SUBJECT: TECHNICAL SPECIFICATION CHANGES RELATED TO FORMATION OF

THE NUCLEAR ACTIVITIES PLANT ORGANIZATION - PALISADES PLANT

Amendment No. 75 License No. DPR-20

ATTACHMENT TO LICENSE AMENDMENT NO. 75 PROVISIONAL OPERATING LICENSE NO. DPR-20

Figure 6.2-1

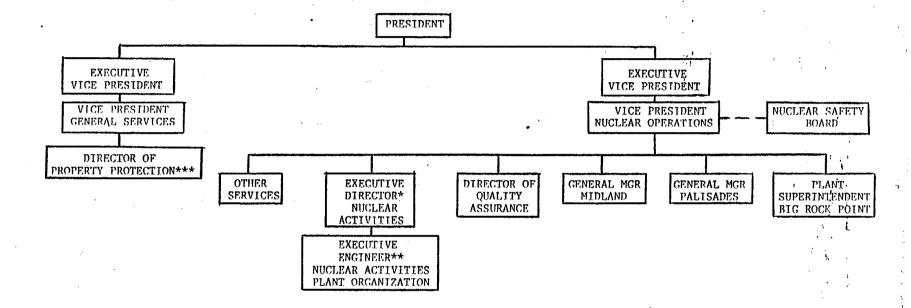
Figure 6.2-1. Although the licensee did not mention in its application that changes are to be made in Figure 6.2-1, which shows the off-site organization for plant management and technical support, the proposed Figure 6.2-1 incorporates both position title changes and elimination and addition of positions and organizational units.

- a. The name of the Safety and Audit Review Board has been changed to Nuclear Safety Board. The name change has no safety significance (our evaluation of the changes in functions of the Board is given below) and is, therefore, acceptable.
- b. The executive position directly responsible for nuclear operations has been changed from Vice President - Production and Transmission to Vice President - Nuclear Operations. And the position of Manager of Production - Nuclear, to which the nuclear plant superintendents reported, has been eliminated so that the plant superintendent/manager

would report directly to the Vice President - Nuclear Operations. We consider these changes to be acceptable because contact between the plant superintendent/managers and the responsible corporate executive will be direct, thus, improving communications.

- The organizations headed by the Manager of Maintenance and Administrac. tive Services are not shown as such on the proposed Figure 6.2-1. However, in Part VIII of the licensee's letter of July 20, 1982, Figure 3 of the proposed Draft Revision to Consumers Power Company's Quality Assurance Program Description for Operational Nuclear Power Plants shows a Nuclear Training Director and a Nuclear Planning and Administration Director both reporting directly to the Vice President -Nuclear Operations. We consider these changes to be acceptable because, as in b. above, communications will be improved. we had no information concerning the deletion from Figure 6.2-1 of the position of the Manager of Maintenance and Administrative Services. In a telephone conversation with the licensee on December 21, 1982, we were informed that the only reason that this position and that of the General Superintendent - Administrative Services were included in Figure 6.2-1 was to show the management chain leading to the Nuclear Training Director. Since, as noted above, the Nuclear Training Director will report directly to the Vice President - Nuclear Operations, there is no longer a need to include the Manager of Maintenance and Administrative Services and the General Superintendent - Administrative Services on the organization chart. We find this to be acceptable.

- d. The position of QA Administrator has been deleted from the proposed Figure 6.2-1. However, the Director of Quality Assurance will continue to report directly to the executive position directly responsible for nuclear operations. The proposed deletion is acceptable because the details of the Quality Assurance organization are not intended to be shown in the Technical Specifications.

- e. The proposed Figure 6.2-1 includes the new positions of Executive Director Nuclear Activities and the Executive Engineer Nuclear Activities Plant Organization. These positions are properly shown on Figure 6.2-1 to show the relationship between management and the Review and Audit functions described in proposed Sections 6.2.3 and 6.5. Our evaluation of proposed Sections 6.2.3, 6.5, 6.7, and 6.8 are given below.
